# COUNTY OF EL DORADO

# DEPARTMENT OF TRANSPORTATION

**SUBJECT: Responses to Bidders' Inquiries No. 3**  
**El Dorado Trail Improvement Project, Forni Road to Missouri Flat Road**  
**(Bid No. GS 08-1021)**

**PLAN VIEW OF RAIL/POST CONNECTION**  
NO SCALE

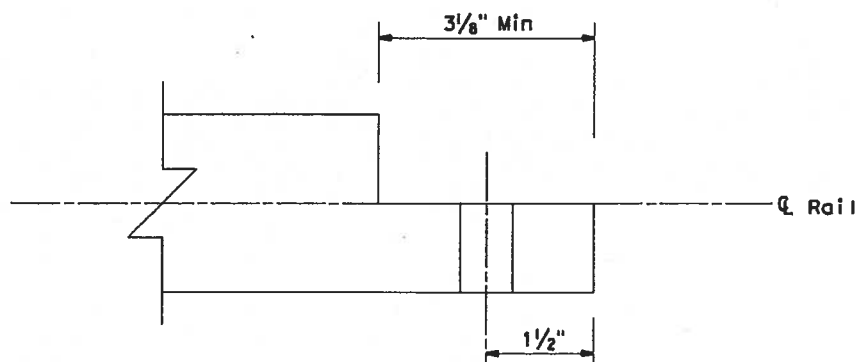
3.08	Plan Sheet C19	<p><b>Question: The revised retaining wall detail in addendum #2 shows timber treated railing being constructed on top of the Retaining walls. What bid item do we bid this on, and are the quantities going to be adjusted to make up for that added treated timber on the retaining walls.</b></p> <p><b>Answer: The limits and quantity of treated timber railing are unchanged. The retaining wall detail in Addendum 2.21 was provided to clarify the connection of the treated timber railing to the retaining wall.</b></p>
